# US 1/SR 4 Widening and Oak Park Bypass

EDS-545(14)(17)(18) Toombs and Emanuel Counties

## Value Engineering Study Report Preliminary Design Stage

ALTERNATIVE  
DESIGN

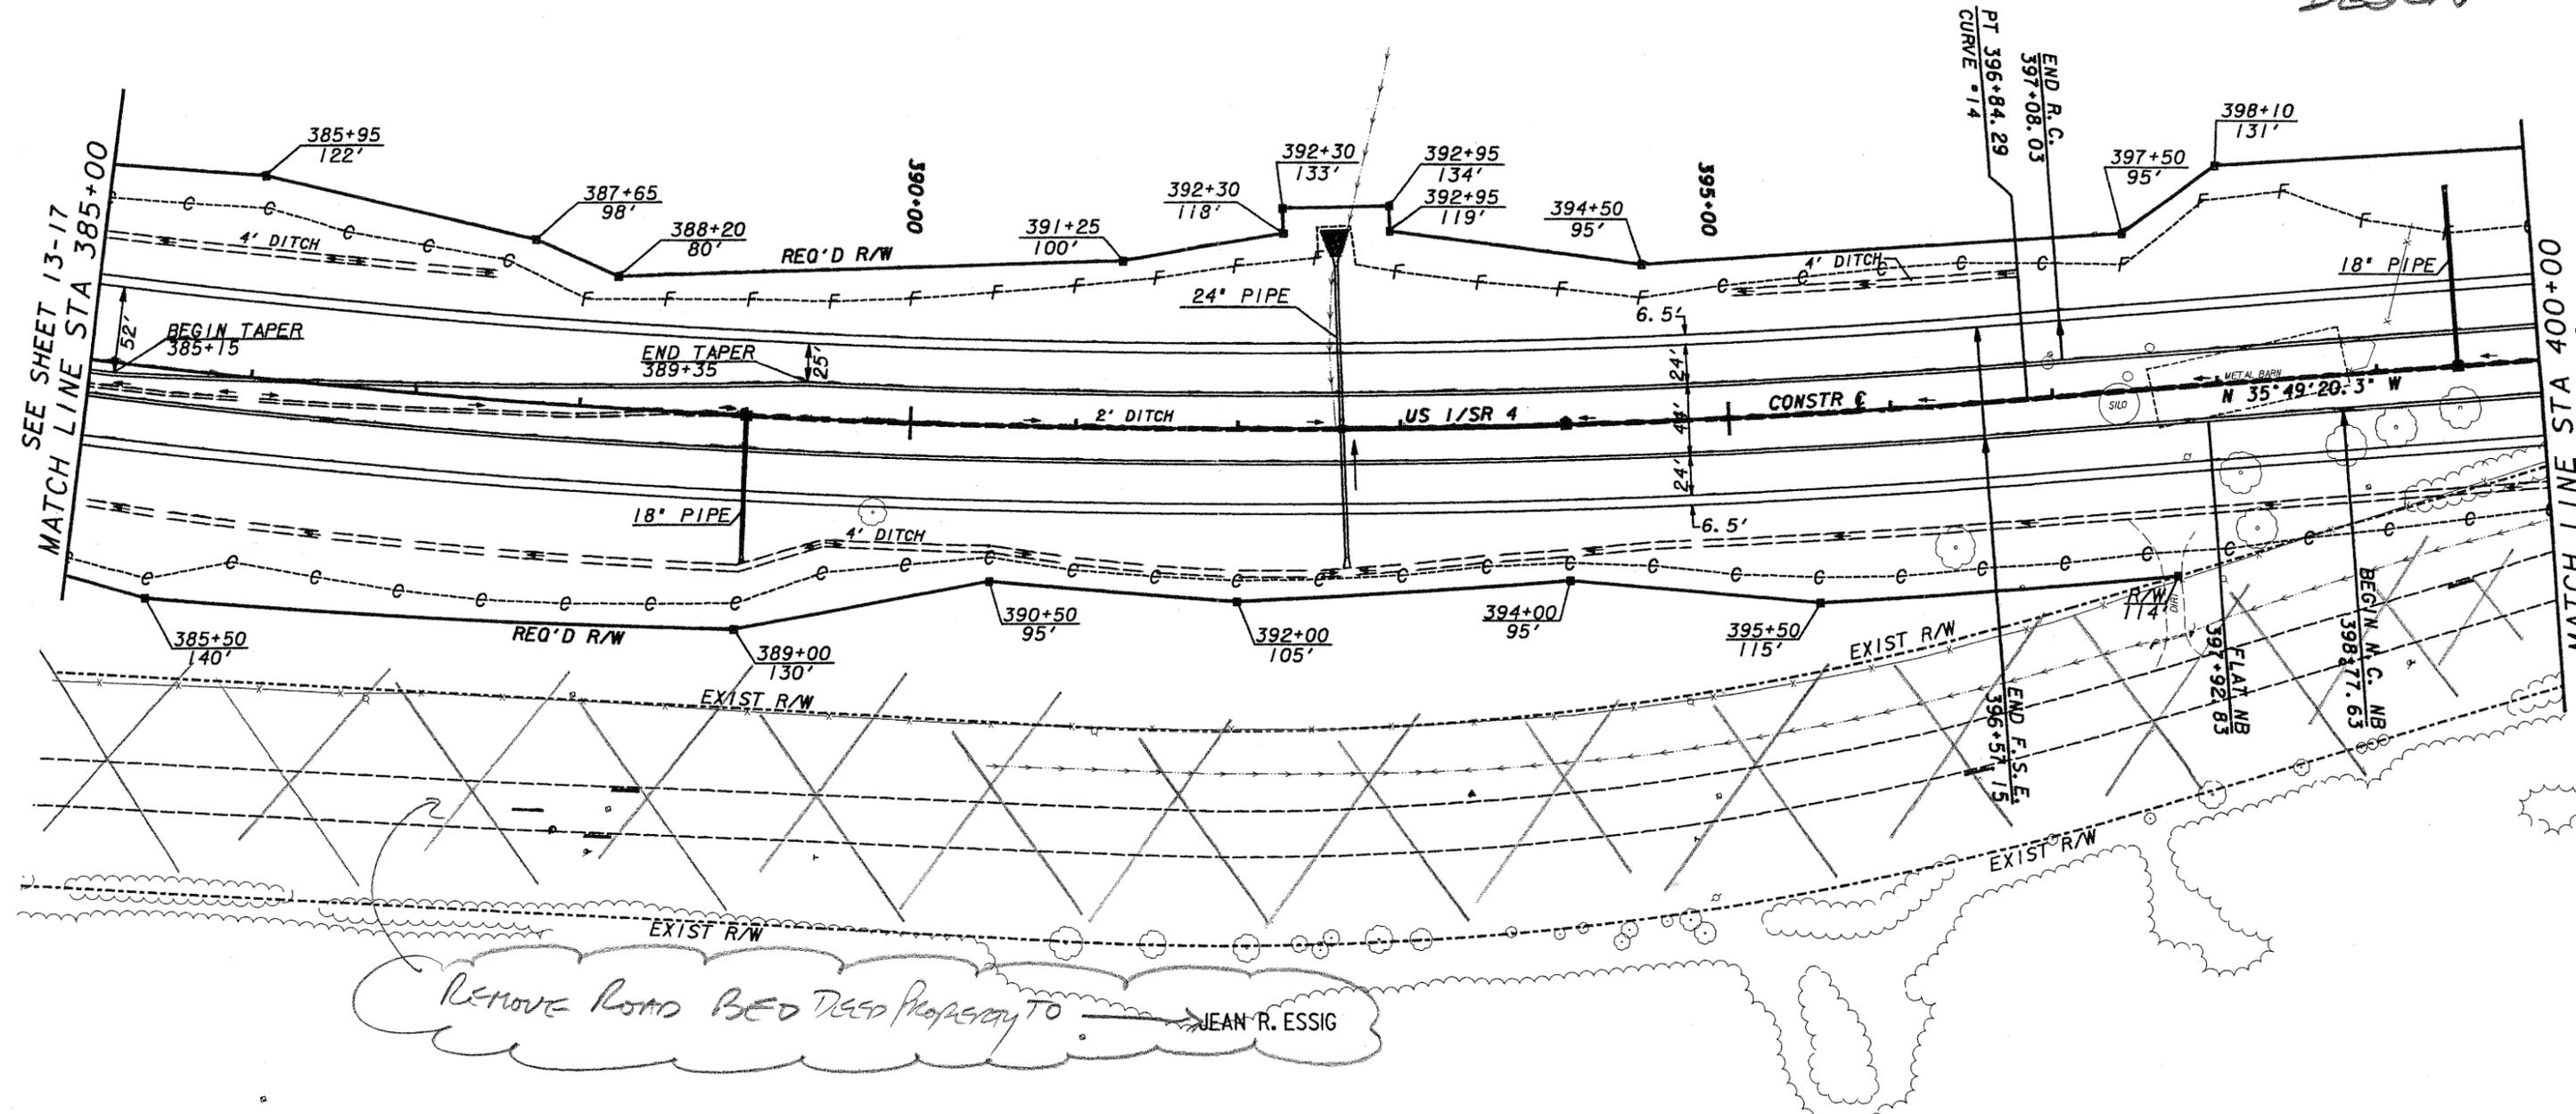
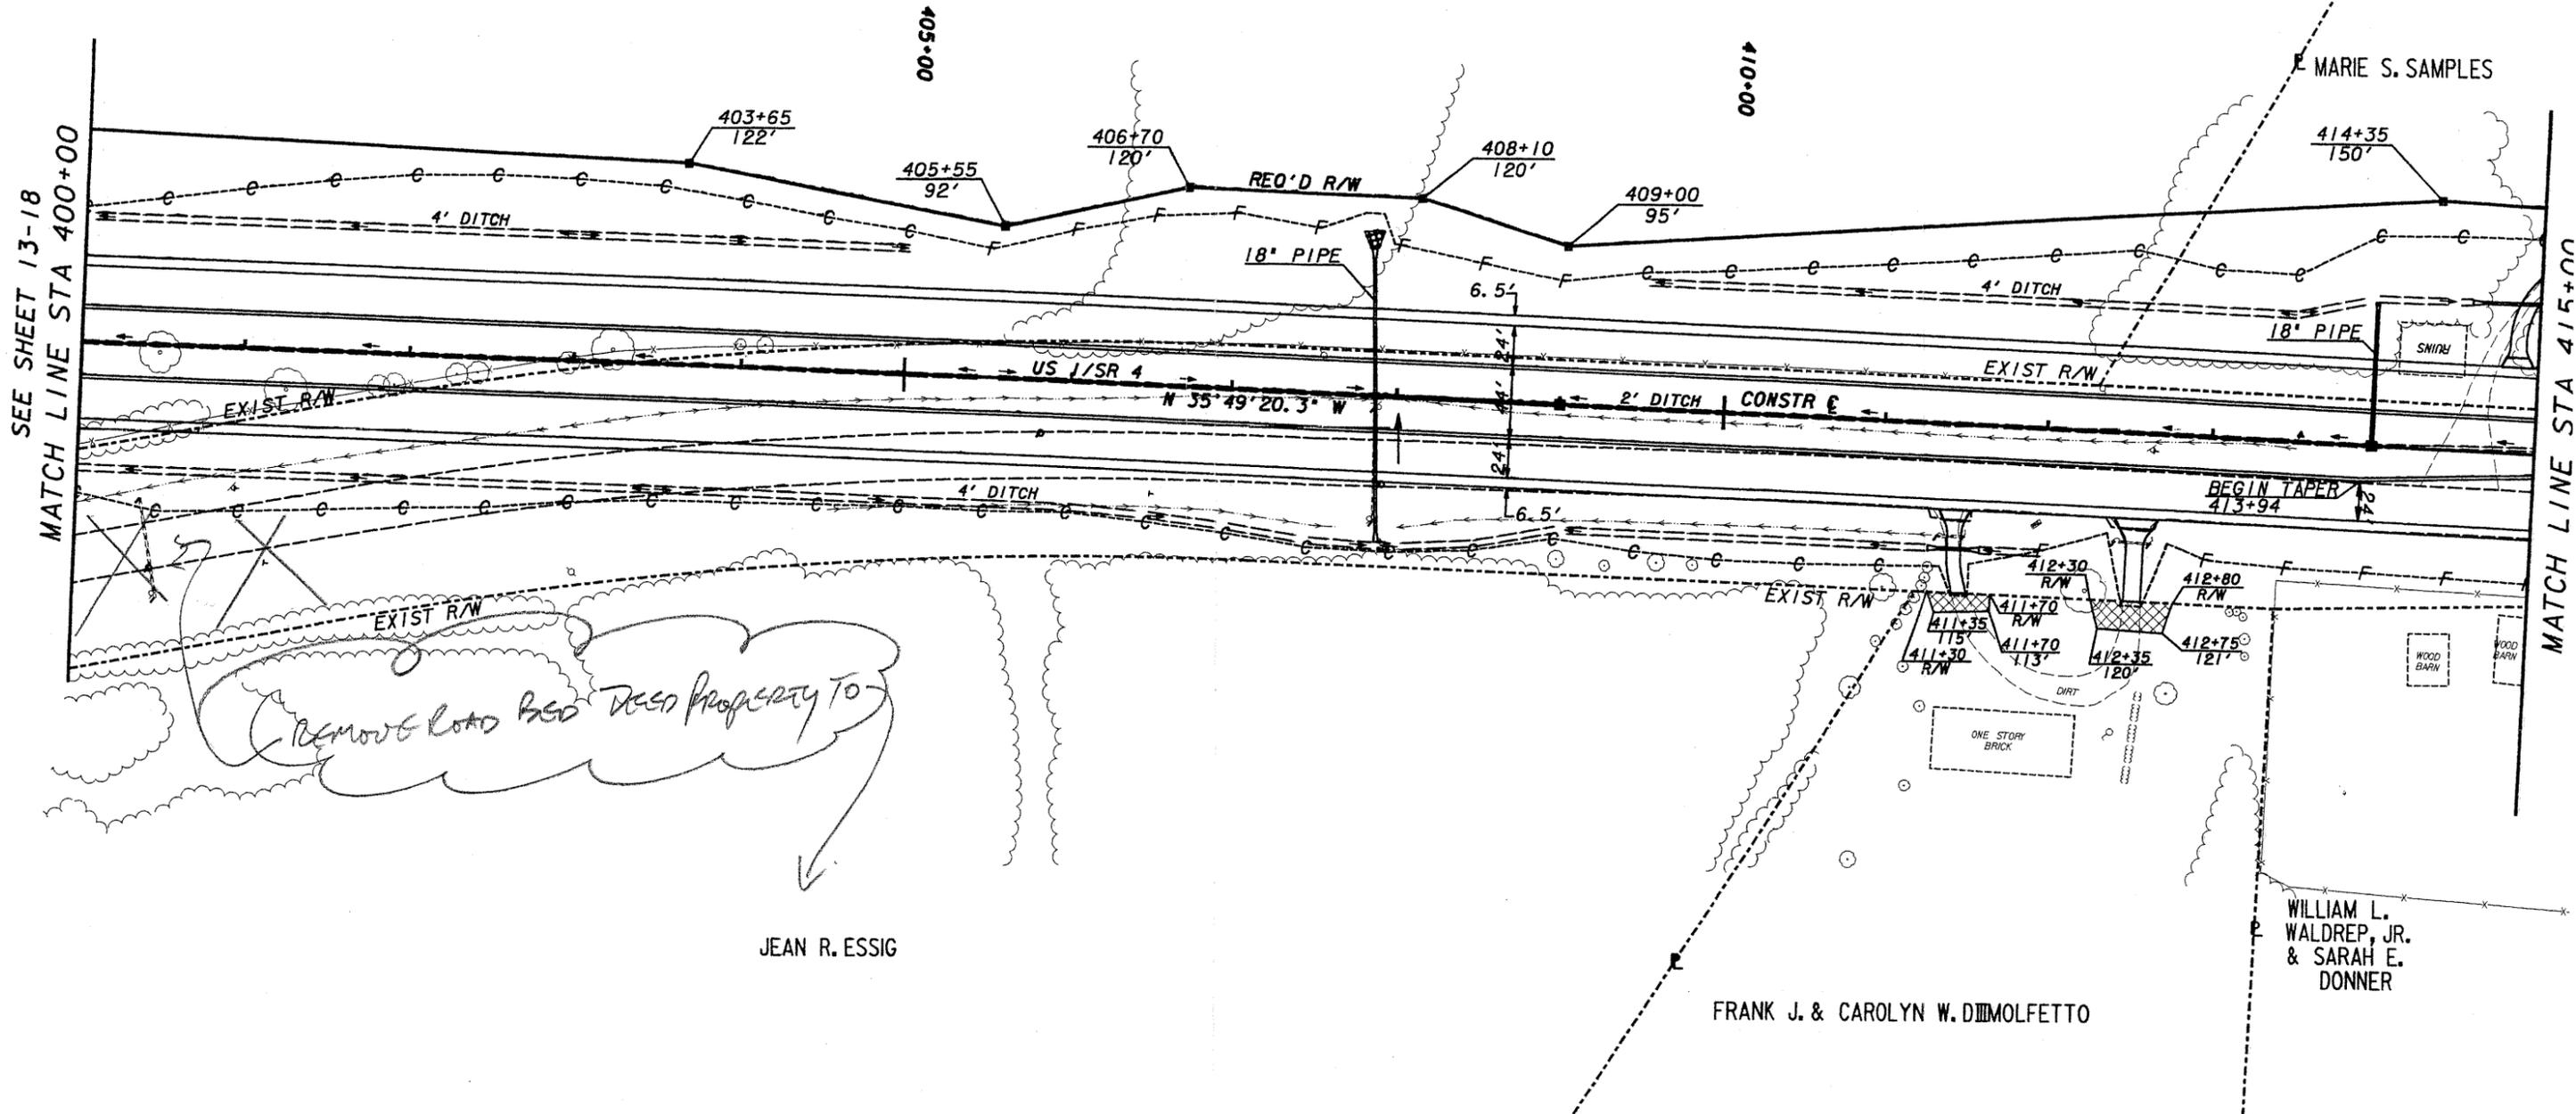
Remove Roadbed  
DEED LAND TO ADJACENT  
OWNER.

Remove Road Base Used Property  
 JEAN R. ESSIG

Remove Road Bed Used Property TO JEAN R. ESSIG
